Product Change Notification

PCN #: 10D-2021

DATE: 12th October 2021

ST60-SIPT

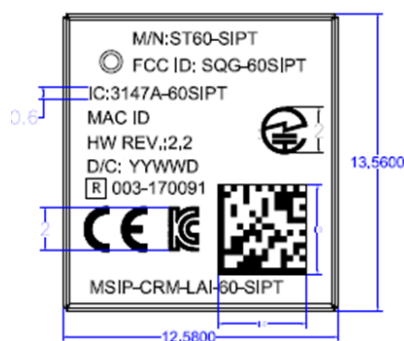
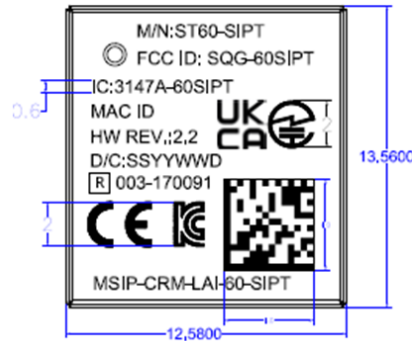
- Date code rule change to SSYYWWD from YYWW. See the drawing in Section 5 below
- Add UKCA logo to product label (laser etching to RF shield of SIP).

ST60-SIPT

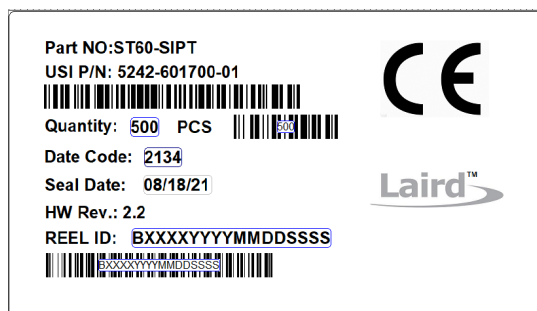
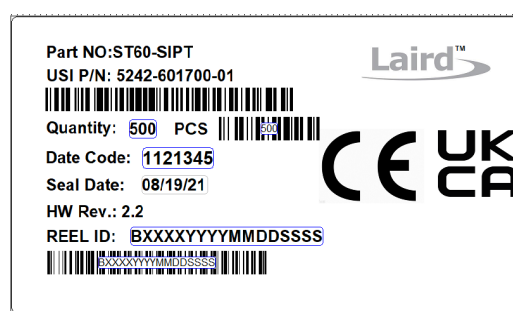
- Date rule change and add UKCA logo to reel/bag/box label

ST60-SIPT

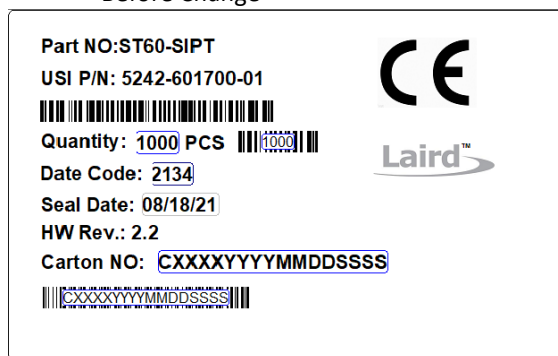
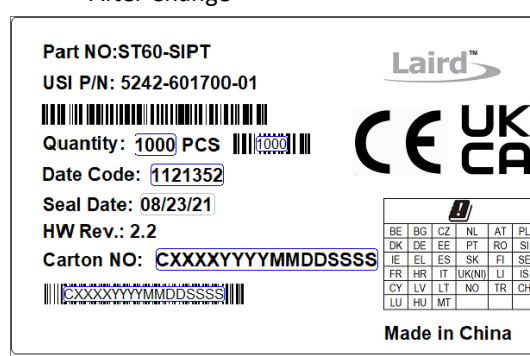
- Date code rule change and add UKCA logo and Pictogram to carton label
